1 July 2026

RE: RE: OTHER CHANGE TO DEVELOPMENT PERMIT NO. MCU/2020/1802 & RAL/2020/1808 FOR COMBINED MATERIAL CHANGE OF USE – IMPACT – RETIREMENT FACILITY (183 UNITS) AND RECONFIGURING A LOT – SUBDIVIDING FOUR (4) LOTS INTO FIVE (5) LOTS, AND OPERATIONAL WORKS – STATE ASSESSABLE WATERWAY BARRIER WORKS

25 TALL OAK DRIVE, COTSWOLD HILLS QLD 4350, 1-11 TALLOWOOD BOULEVARD, LOT 999 SP290343 MORRIS COURT, LOT 904 SP263388 & LOT 4 RP22818 GOWRIE JUNCTION ROAD, COTSWOLD HILLS QLD 4350 - LOT 1 SP330786 (FORMERLY LOT 999 SP290343, LOT 904 SP263388 & LOT 4 RP22818) AND LOT 3 SP338483

Figure 1 is the approved development layout. **Figure 2** is the proposed change development layout.

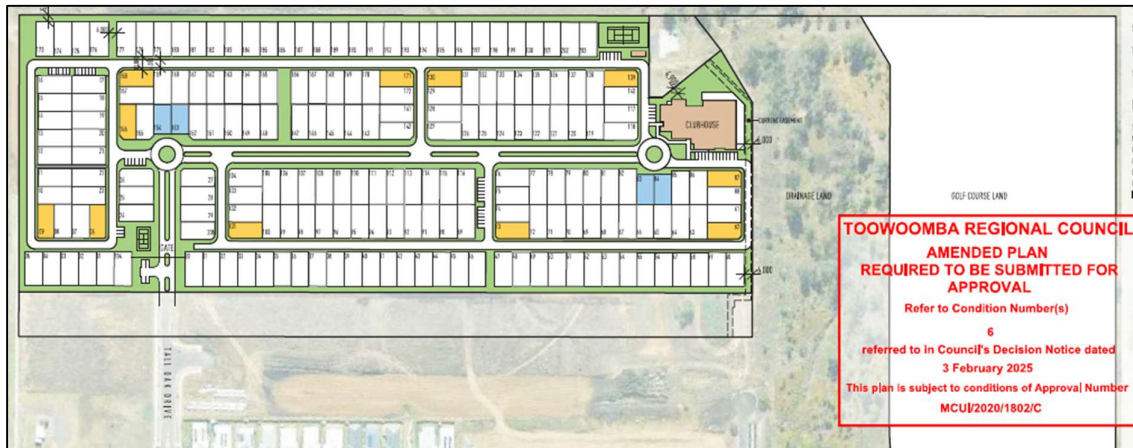
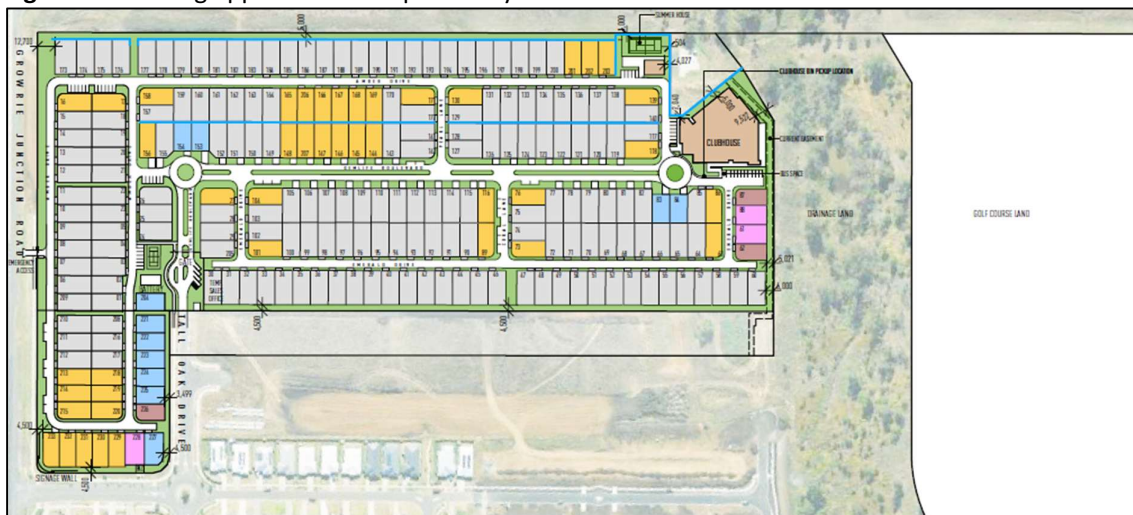
- Introduce Lot 3 SP338483 and increase the number of approved units from 205 to 229 lots.
- Corresponding amendments to the overall layout to accommodate the introduction of lot 3.

- Minor modifications to the internal driveway alignment and the car parking arrangement.
 - Interface changes between the proposed units and Hermitage – particularly between the Summer House/Tennis Court and Hermitage Road.
